**BELL BEND NUCLEAR POWER PLANT
RESPONSE TO ENVIRONMENTAL
INFORMATION NEEDS, THIRD SUBMITTAL
BNP-2010-201 Docket No. 52-039**

**Information Needs Responses
Alternative Sites Audit
June 15-17, 2010
Bell Bend Nuclear Power Plant
Luzerne County Pennsylvania**

Figure 1. Surface Water Users within a Five-Mile Radius of the Montour Site

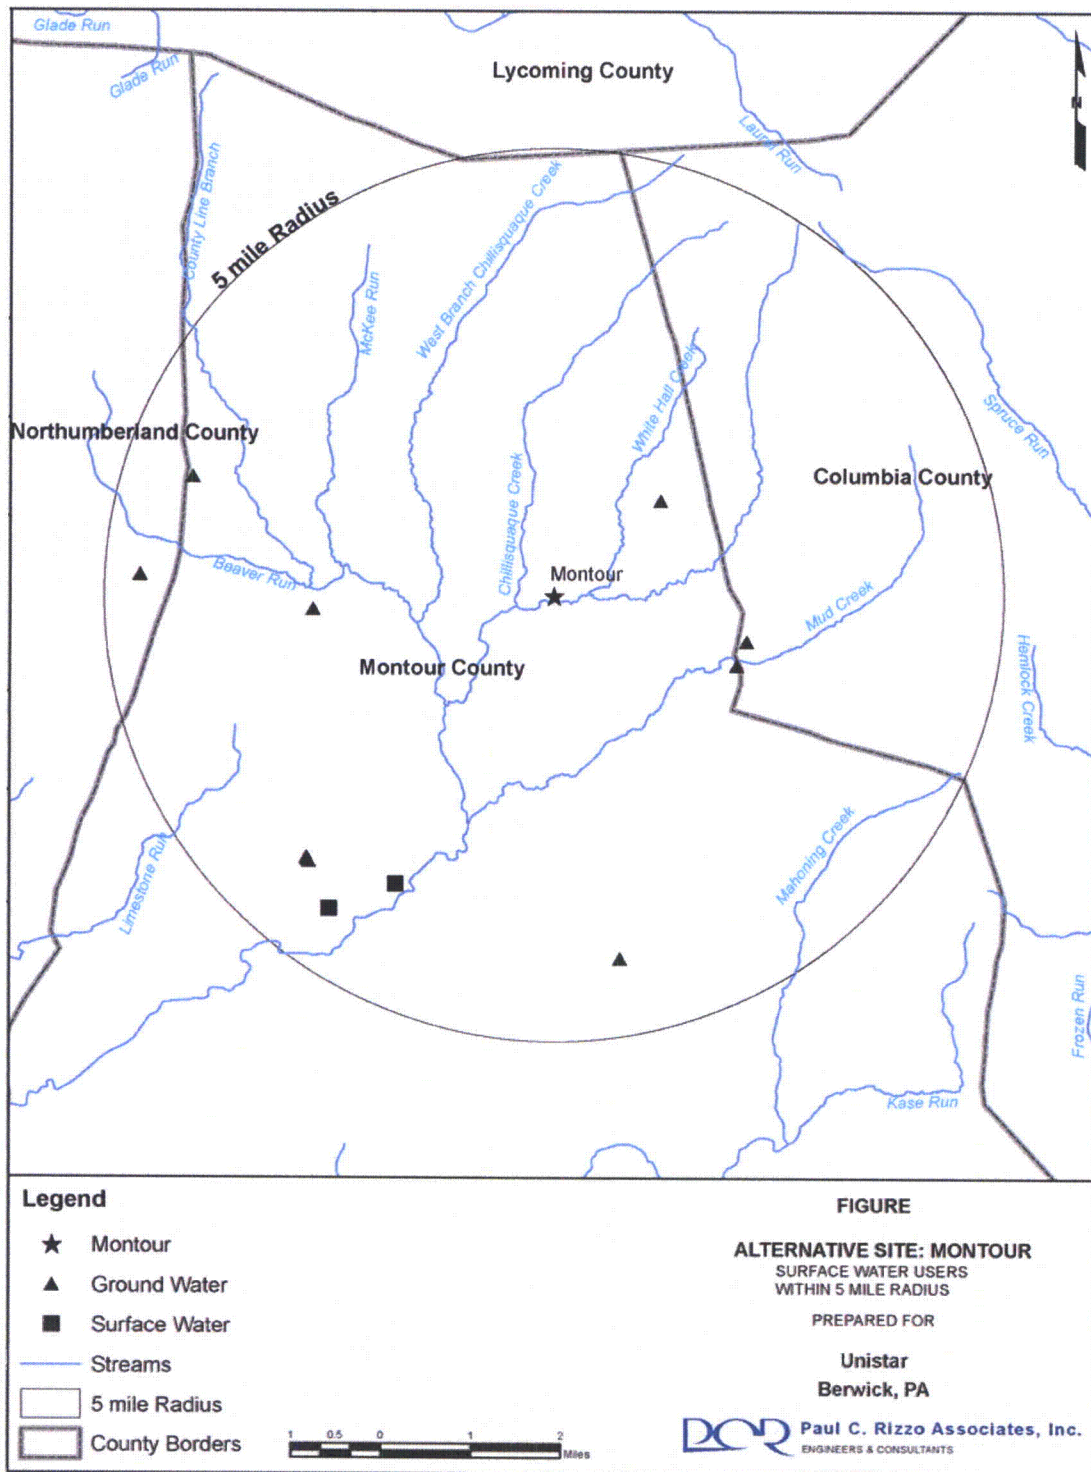
Information Needs Text: Provide an expert who can discuss groundwater at all alternative sites. Please make available a list of nearby groundwater and surface-water users who could be affected directly by plant construction and operation.

Surface water users within a five-mile radius of the Montour, Humboldt, and Seedco alternative sites are shown on Figures 1, 2, and 3, respectively. Surface water used for the power plant will be obtained from and returned to the Susquehanna River. Therefore, local surface water bodies will not be affected during plant operations. Best Management Practices (BMP) will be used during construction to minimize erosion and sediment entering local streams.
